Service Bulletin No. SB-AG-24

June 20, 1990

HORIZONTAL STABILIZER STRUT ATTACH INSPECTION

-242 GUSSET

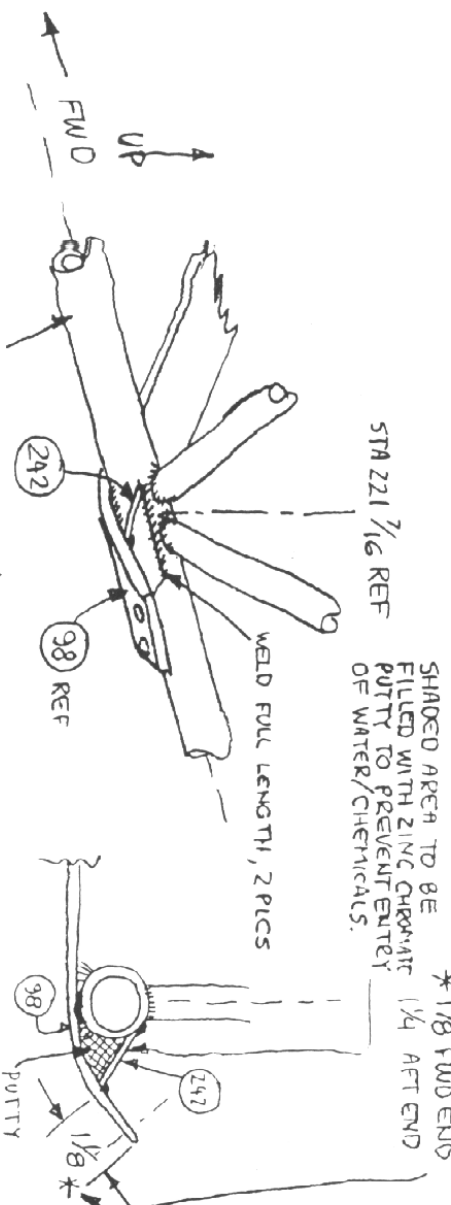
TITLE		FRAME FUSELAGE	
REASON		TO STRENGTHEN STAB STRUT	
ATTACH POINT			
THIS ORDER TO BE USED AS PART OF DWG AND SUPERSEDES PARTS AS SHOWN IN			
REVISE P/D AND SW TO AGREE			
DWG REV		G	
L ETT/EM			
CHANGE EFFECTIVE ON		NOTED	
REV A			
REV B			
WAS		REQ	
CLASSIFICATION			
Alyes Corporation Albany, Georgia		10601	
MODEL		S2R	
DRAWING NUMBER		G-23	
EQU NUMBER			
CUSTOMER			
COMPANY			
REQUESTED BY			
VENDOR

(1) CREATE ITEM -242 GUSSET, MATL 1/8" 4130 STEEL QTY REQD 2 PER FUSELAGE... PER VIEW.

6. If a crack is present on either side, install part 10601-242 in accordance with 10601 ECN G-23 provided as page 4 of this service bulletin. Prior to welding, drill a small (1/16") hole in one of the diagonal members near the attach tab. This will prevent a build up pressure in the frame. Weld the hole closed when the repair is finished. Sand, prime and paint the repair. Pack the resulting triangular cove with zinc chromate putty to prevent a build up of chemical residue from accumulating.

LOWER LEFT LONGERON (REF)
R/P/SI DE SANGE AS SHOWN
